Service Bulletin No: 51-001

ATA Chapter: 51

AIRCRAFT STRUCTURE - GENERAL**DO A CHECK OF THE MATERIAL SPECIFICATION USED DURING MANUFACTURE AND, IF NECESSARY, DO A CHECK FOR CRACKS OR REPLACE THE PART****1. Planning Information****A. Effectivity**

Nose Rib 1 - Inspection (If Necessary)
Figure 3

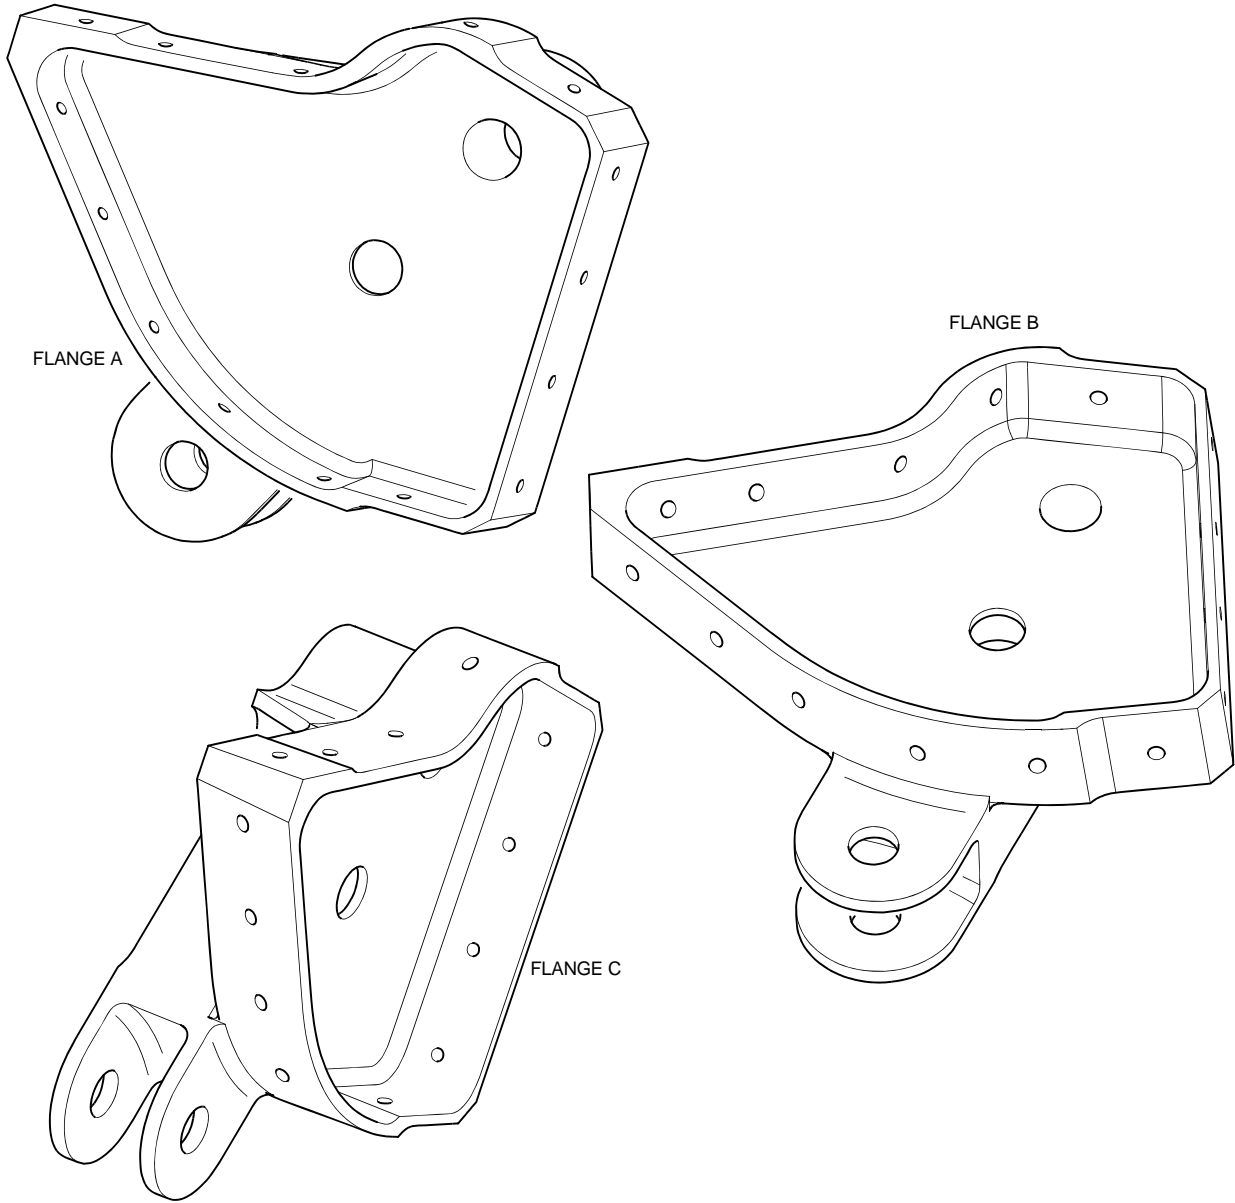
- (b) If you find an aileron nose rib made from AA2024-T351, continue this Service Bulletin from Step 3.B.(1)(d).
- (c) If the aileron nose ribs are made from AA2124-T851, re-identify them (Ref. Para. 2.D.) and continue this Service Bulletin from Step 3.B.(2).

- 1 Use the absorbent paper (Material No. P02-031) made moist with the solvent (Material No. P01-010) and remove the dirt and grease from the inspection areas of the left-aileron nose-rib 1 assembly (P/N 557.51.09.101).

- NOTE:** It is not necessary to remove the layers of surface protection to do the inspection.
- 2 Use a bright light source and a mirror to examine the inspection areas of the left-aileron nose-rib 1 for cracks.

Lower Rudder Bracket - Inspection (If Necessary)
Figure 5

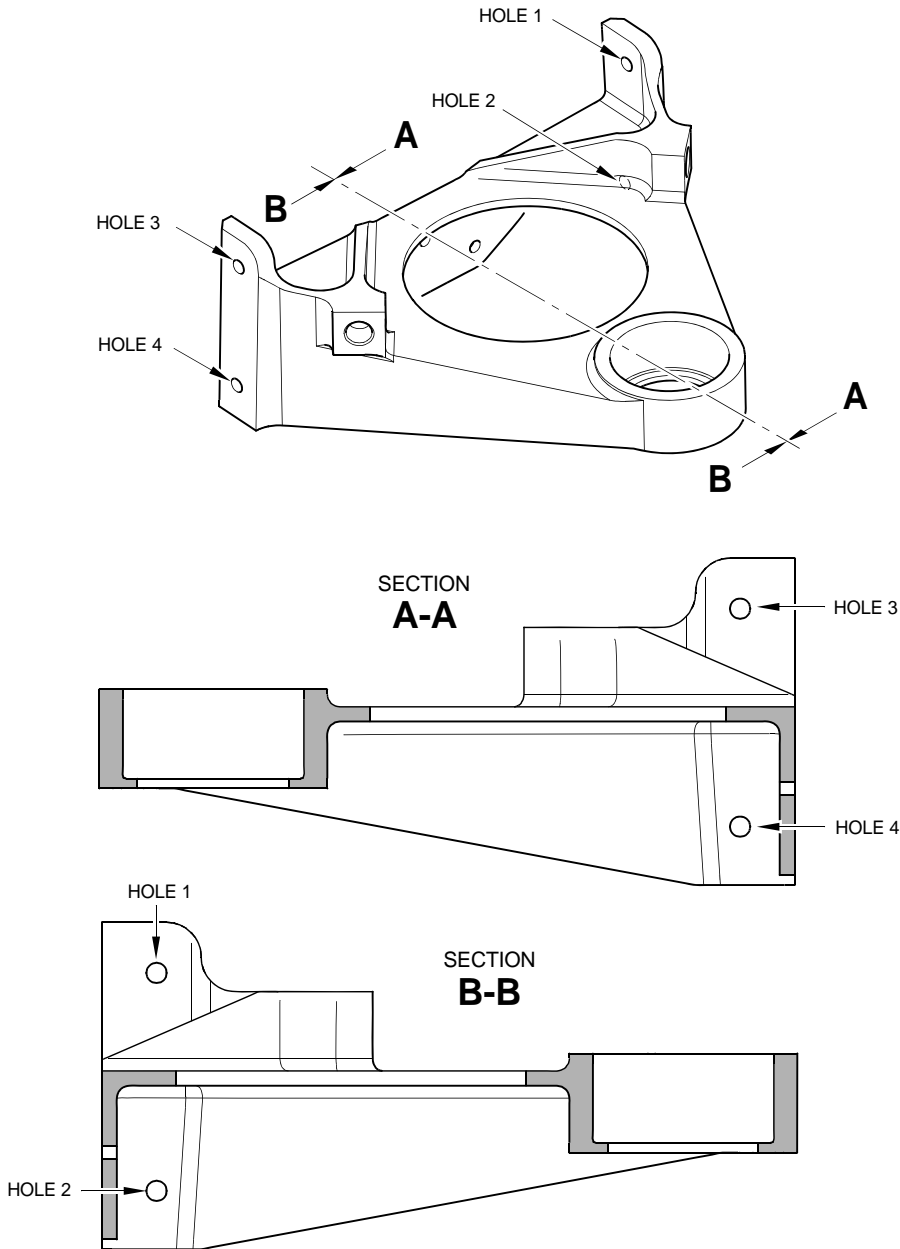
- 2 Remove the nuts (3), the washers (2) and the bolts (1) from the four attachment bolt holes of the rudder lower-hinge-bracket (4).

- 3 Use the absorbent paper (Material No. P02-031) made moist with the solvent (Material No. P01-010) and remove the dirt and grease from the inspection areas of the rudder lower-hinge bearing-bracket.

Frame 3 Pick-Up Brackets - Inspection (If Necessary)
Figure 7

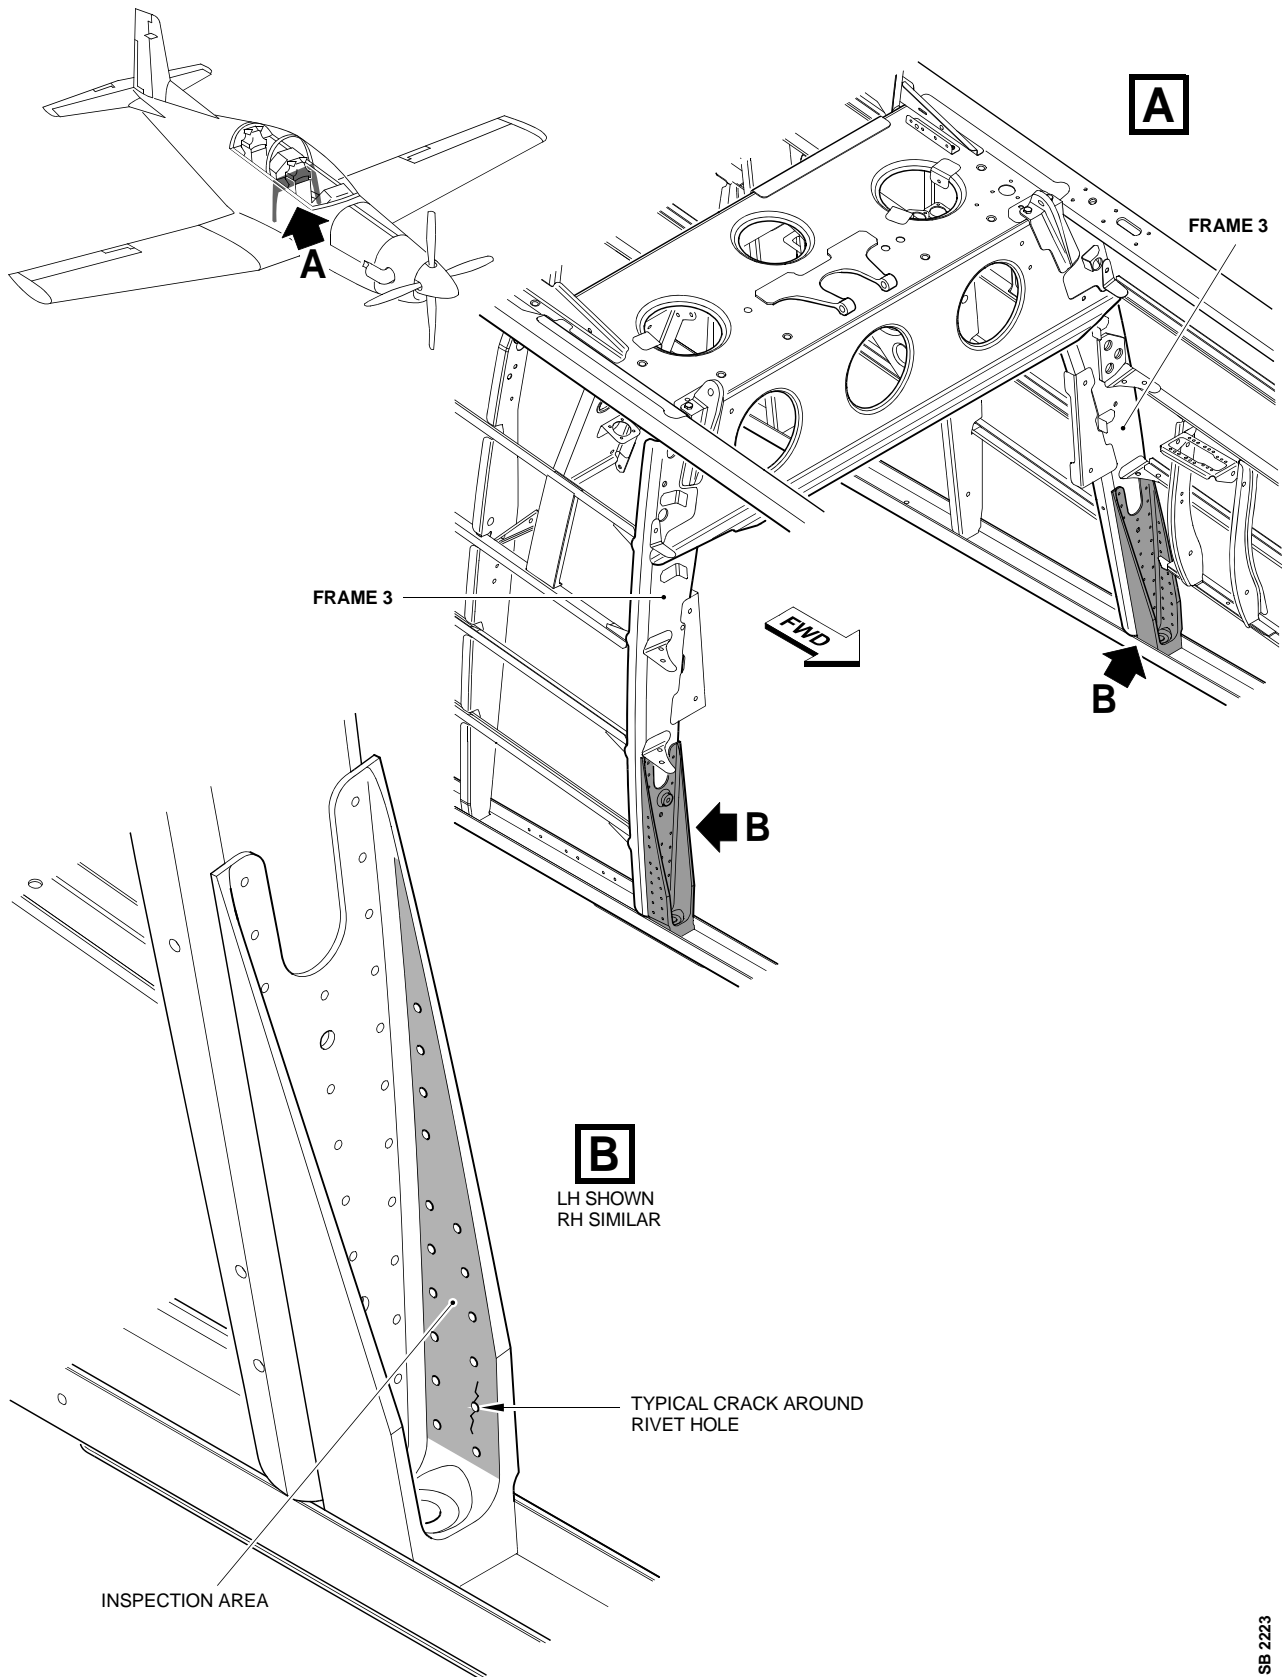
1 Use the absorbent paper (Material No. P02-031) made moist with the solvent (Material No. P01-010) and remove the dirt and grease from the inspection areas of the left frame 3 pick-up bracket.

Left and Right Flap Bearing Support-Bracket - Inspection (If Necessary)
Figure 9

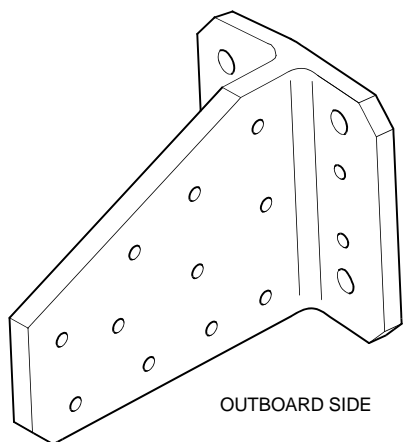
1 Use the absorbent paper (Material No. P02-031) made moist with the solvent (Material No. P01-010) and remove the dirt and grease from the inspection areas of the left flap bearing support-bracket.

Rear Control-Column Support-Bearing Bracket - Inspection (If Necessary)
Figure 11, Sheet 1 of 2

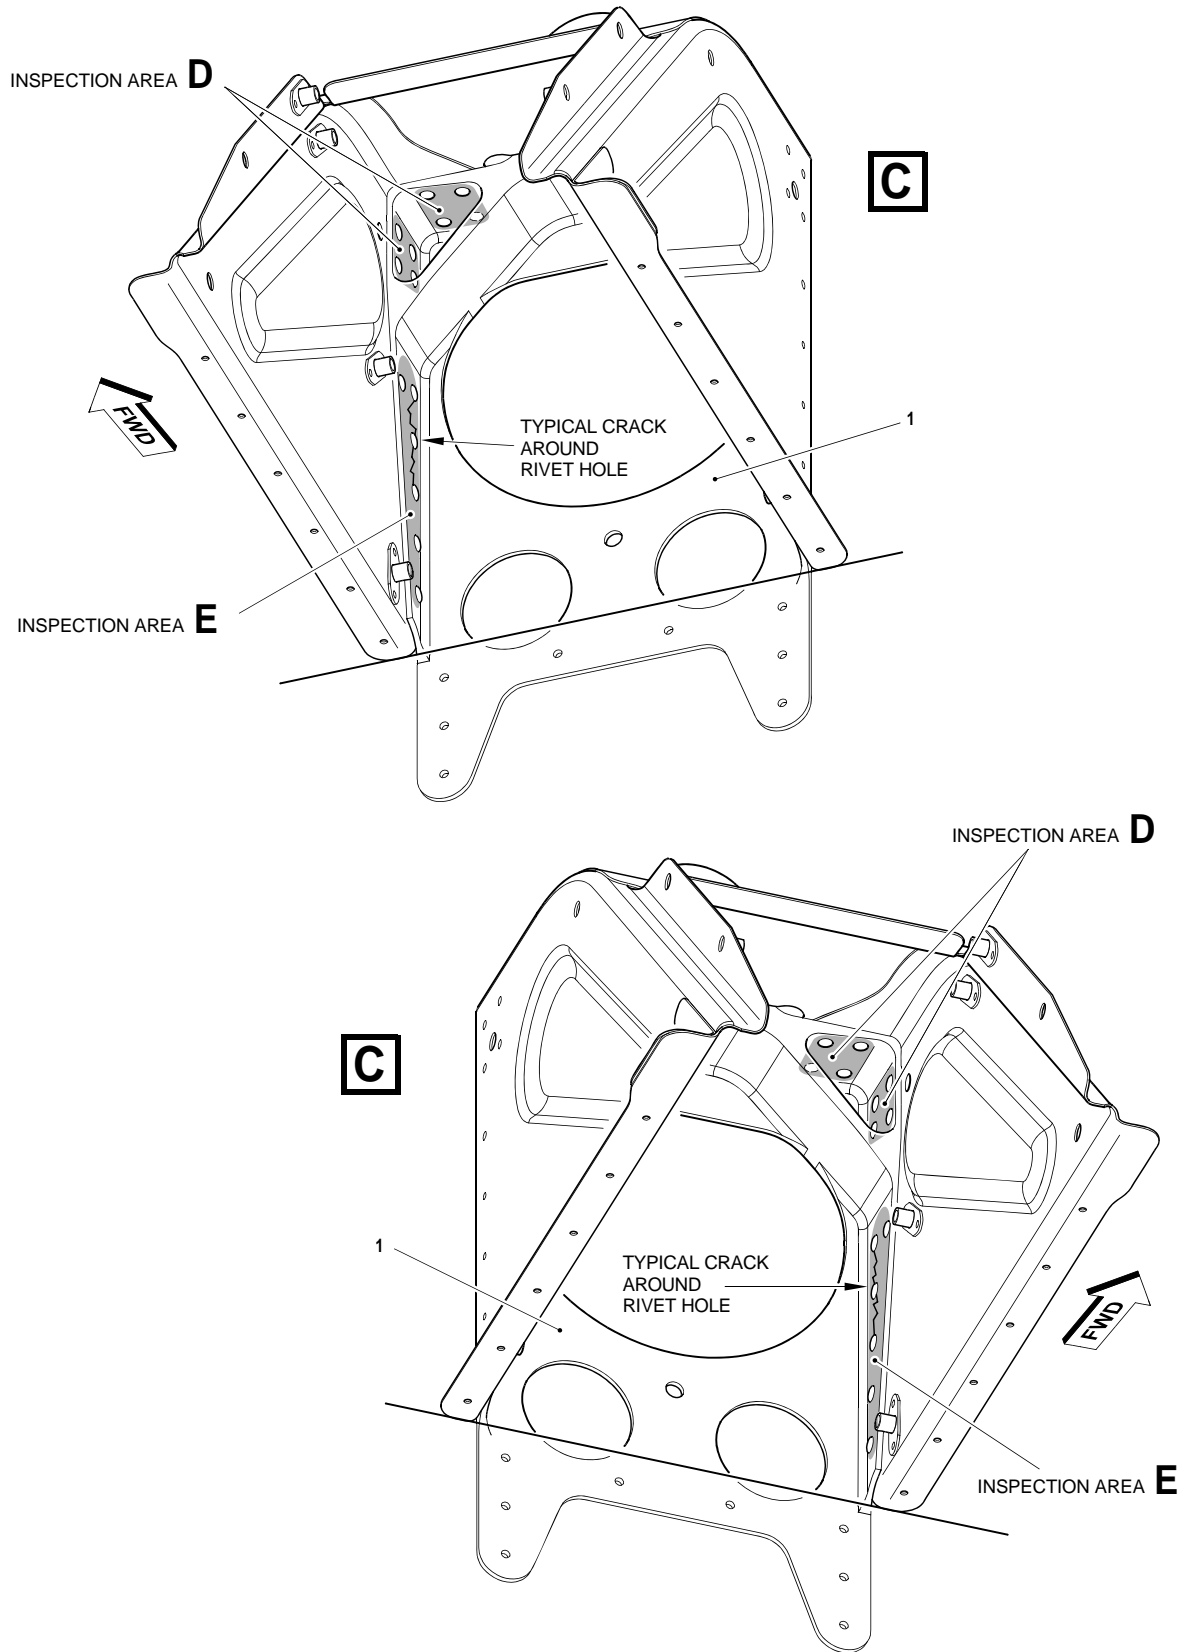
1 If necessary, use the absorbent paper (Material No. P02-031) made moist with the solvent (Material No. P01-010) and remove the dirt and grease from the inspection areas of the rear control-column support-bearing bracket (1).

Inspection / Replacement of the Lever on the Rear Control Column
Figure 13, Sheet 1 of 2

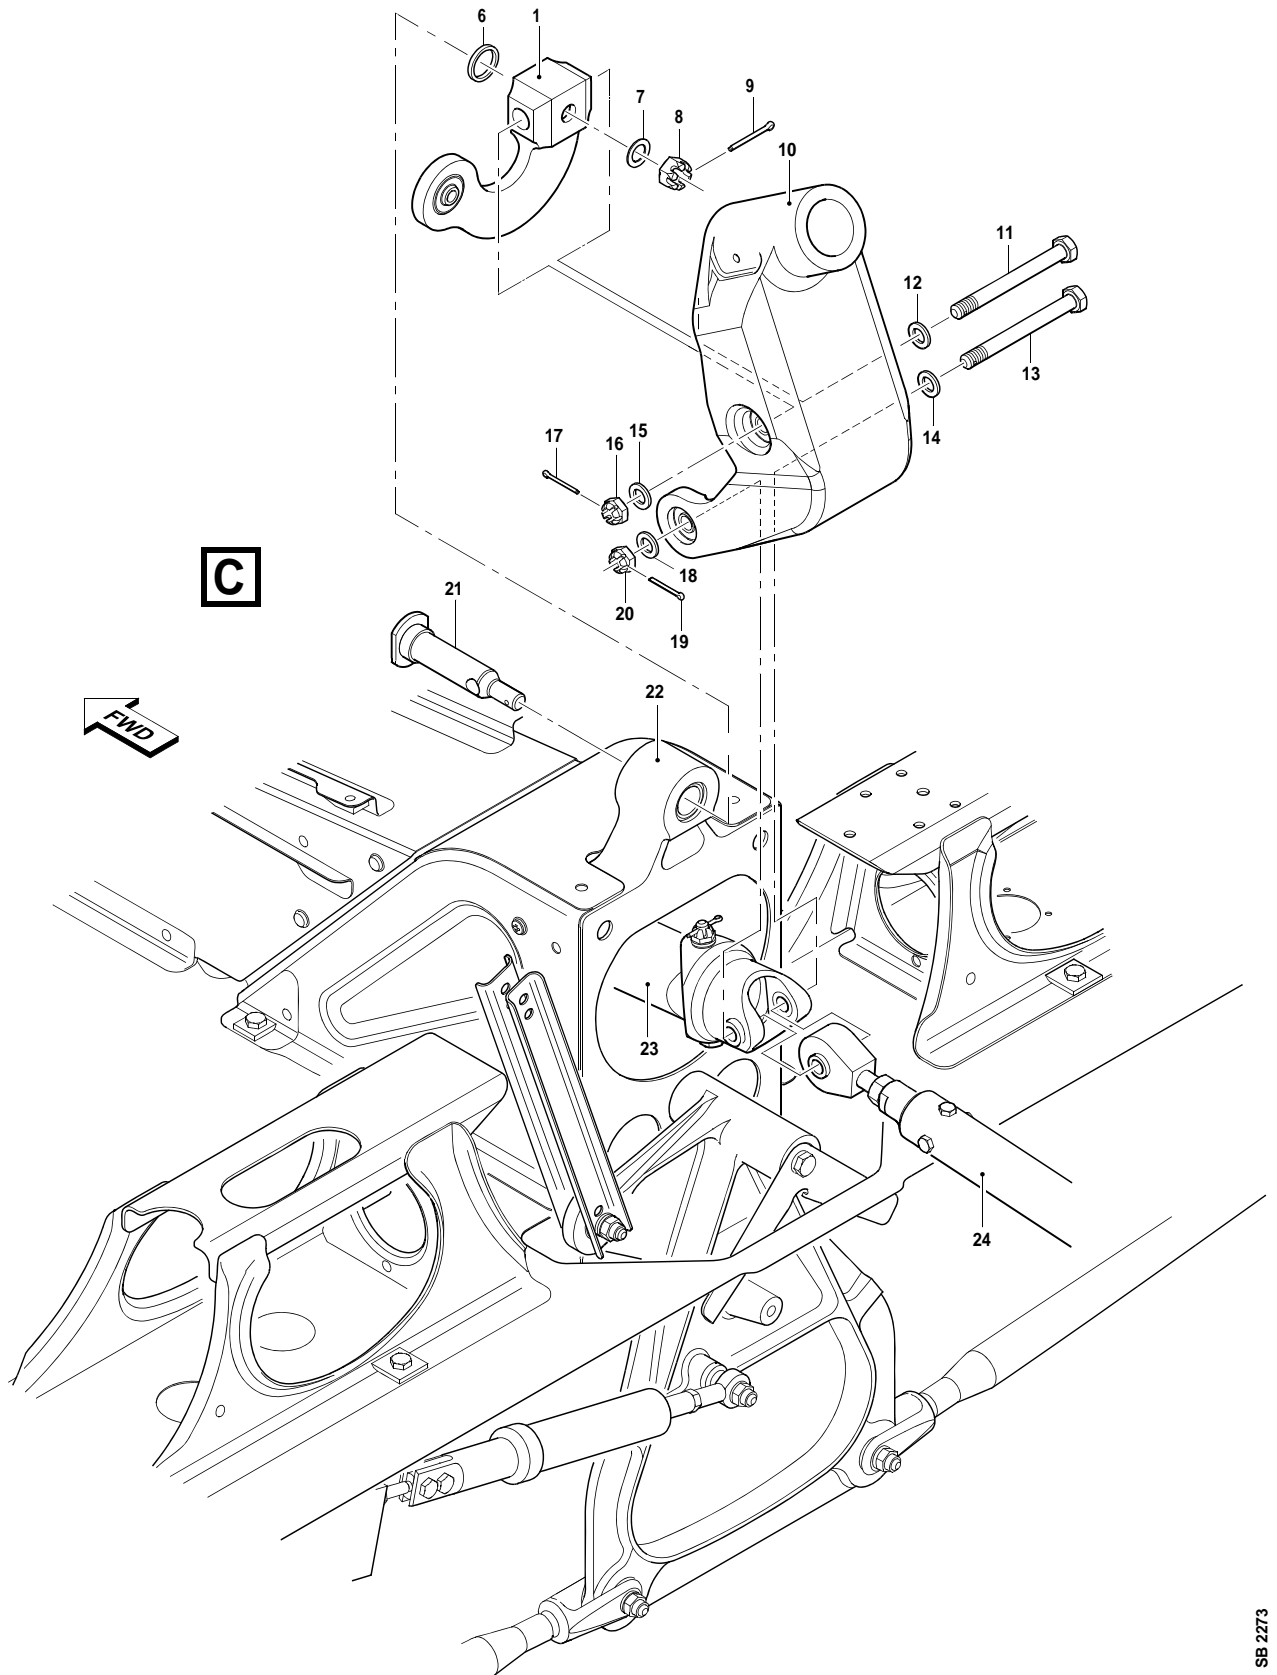
(d) Replace the lever (Ref. Fig. 13):

1 Remove the nut (4), the washers (3) and the bolt (2).

- 2 Move the forward and aft channels (5) clear of the lever assembly, (1).
- 3 Remove, and discard, the cotter pin (19).
- 4 Remove the nut (20), the washer (18), the washer (14) and the bolt (13).

- 5 Disconnect the rear control column assembly (24) from the rod assembly (23).
- 6 Remove, and discard, the cotter pin (17).
- 7 Remove the nut (16), the washer (15), the washer (12) (if installed) and the bolt (11).

- 8 Remove the rear control column assembly (10) from the aircraft.
- 9 Remove, and discard, the cotter pin (9).
- 10 Remove the nut (8), the washer (7), the special washer (6) and the special bolt (21) from the rear control-column support-bearing bracket (22).

- 11 Remove, and discard, the lever assembly (1) from the aircraft.
- 12 Put the new lever assembly (1) (P/N 527.30.09.223) in position in the aircraft.
